FCO 512-00386A: Anti-noise Foams Kit For ThermoFlex Mid II Platesetter

Document number: 719-00733B-EN Rev B

Applies to	Kodak® ThermoFlex® Mid II	**Priority:** Next failure
Component	Side doors and rear panel

Right side door with foam units attached. The black foam units (252-12612A and 252-12614A) are underneath the silver foam units (252-12611A and 252-12613A).

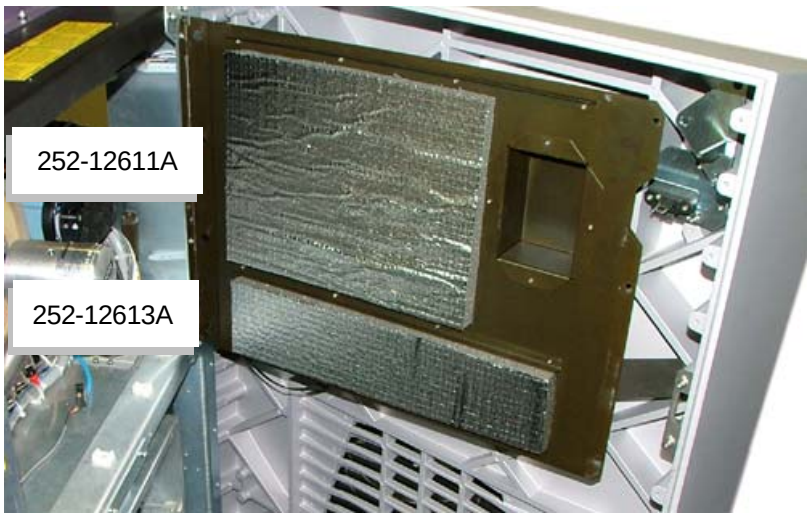
1. In the ThermoFlex Controller software, open the loading table.
2. From the front of the platesetter, access the side doors:
   a. Slide open the loading tray.
   b. Open the front panel.
   c. Open the side doors.
3. On the right side door, attach the black upper foam unit (252-12612A) and thin black lower foam unit (252-12614A) to the door, and then attach the silver upper foam unit (252-12611A) and silver lower foam unit (252-12613A) to the black foam units, as shown.

Left side door with foam units attached. The black foam unit (252-12616) is underneath the silver foam unit 252-12615A.

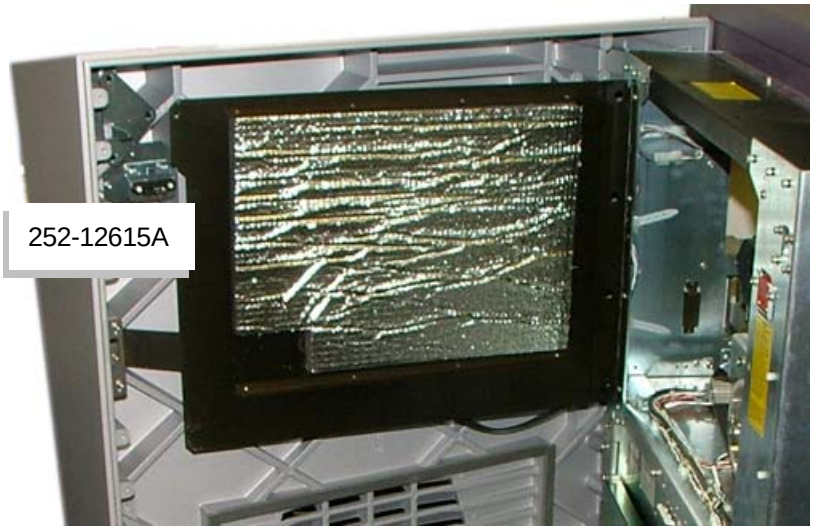
4. On the left side door, attach the thin black foam unit (252-12616A) to the door, and then attach the silver foam unit (252-12615A) to the black foam unit, as shown.
